**STAFF REPORT AND RECOMMENDATION**  
**CU 17-03 / SP 17-127 / VR 17-10 / VR 17-12 / VR 17-13**  
**November 20, 2017**

**FILE NO.:** CU 17-03: Conditional Use  
SP 17-127: Site Plan and Design Review  
VR 17-10, 12, 13: Variance

**REQUEST:** Conditional Use, Site Plan and Design Review and Variance Application for new Modular 2-Classroom Building At Gardiner Middle School.

**LOCATION:** 180 Ethel Street, Oregon City, OR 97045  
Clackamas County Map: 3-2E-06AD-07800

Figure 3. Site Plan Detail

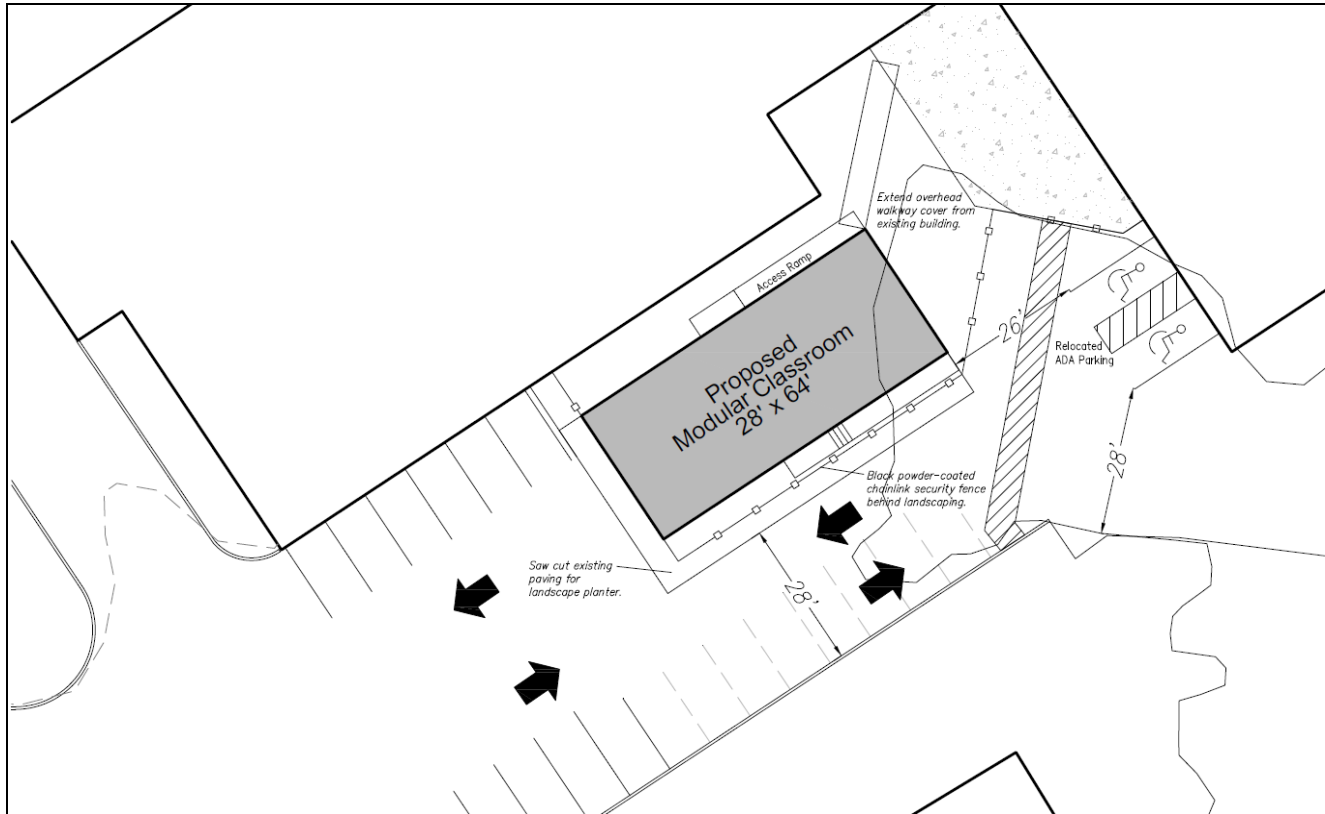
**Finding: Complies with Condition.** The area where the modular building will be placed is paved with asphalt. A ramp will connect the classroom entrances to the existing pavement and a covered walkway striped with paint from the classrooms to the school entrance is proposed. No other changes to pedestrian circulation are proposed. The applicant did not show the width of the walkway. Prior to issuance of building permits, the applicant shall submit sufficient documentation regarding the covered pedestrian walkway to demonstrate the width of the walking is at least five feet.

1. Prior to issuance of building permits, the applicant shall submit sufficient documentation regarding the covered pedestrian walkway to demonstrate the width of the walking is at least five feet. *(P)*

Figure 4. Building Elevations

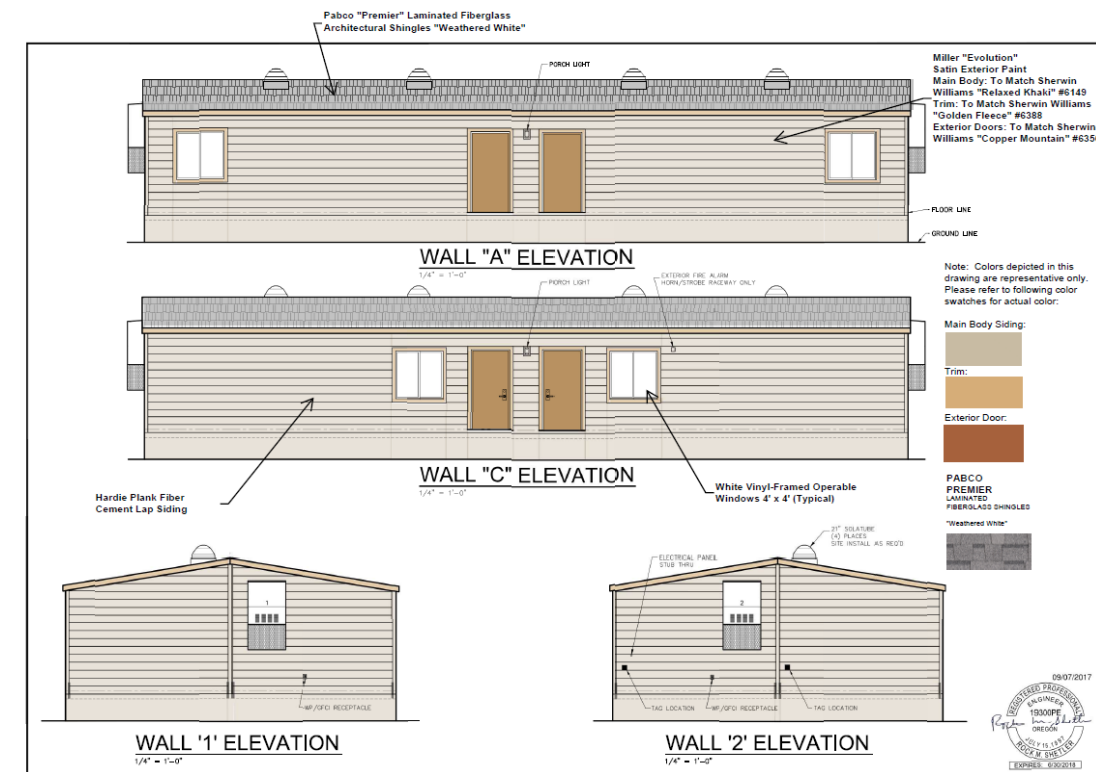
**Finding: Complies with Condition.** The building façade is not visible from the street and staff suggests that this portion of the standard be covered under the variance requested to 17.62.055.D. The primary building entrance does not appear to be clearly defined and framed. The applicant shall propose a sheltering element on the entrances to the classrooms such as an awning, arcade or portico in order to provide shelter from the summer sun and winter weather for approval by the Community Development Director prior to issuance of a building permit. **Staff has determined that it is possible, likely and reasonable that the applicant can meet this standard through the Conditions of Approval.**

5. The applicant shall propose a sheltering element on the entrances to the classrooms such as an awning, arcade or portico in order to provide shelter from the summer sun and winter weather. *(P)*
